## Product Change Notice (PCN)

**PCN Number:** PCN-0456200R-01

Product(s) Affected: *SJ1-351X Series (Parts: SJ1-3513, SJ1-3514 & SJ1-3515)*

<p>Recommended PCB Layout Top View</p>	 <p>Recommended PCB Layout Top View</p>

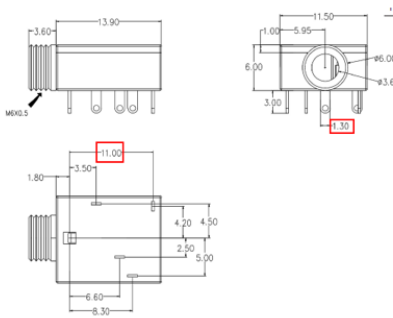
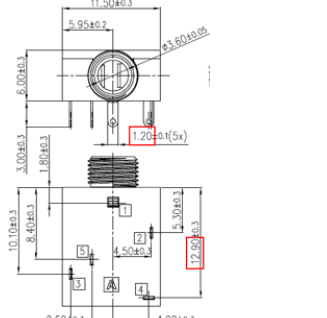
Description of Change: *New Factory Location. Product re-engineered for improved manufacturability and production yield. See image below for reference and check CUI Devices website for updated drawing. Cosmetic differences may be visible and will not affect the form fit and function of the product.*

PREVIOUS CUI DEVICES DETAIL / IMAGE			NEW CUI DEVICES DETAIL / IMAGE		
DESCRIPTION	MATERIAL	PLATING/COLOR	DESCRIPTION	MATERIAL	PLATING/COLOR
terminal 1	brass t=0.3	silver	terminal 1	brass t=0.3	silver over nickel
terminal 2	phosphor bronze t=0.3	silver	terminal 2	copper alloy t=0.25	silver over nickel
terminal 3	brass t=0.3	silver	terminal 3	copper alloy t=0.25	silver over nickel
terminal 4	brass t=0.3	silver	terminal 4	brass t=0.3	silver over nickel
terminal 5	phosphor bronze t=0.3	silver	terminal 5	brass t=0.3	silver over nickel
bushing	brass	nickel	bushing	brass	nickel
spring	steel	black	cover	PBT (UL94V-0)	black
cover	PBT (UL94V-0)	black	housing	PBT (UL94V-0)	black
housing	PBT (UL94V-0)	black	nut	brass	nickel
nut	zinc alloy	tin
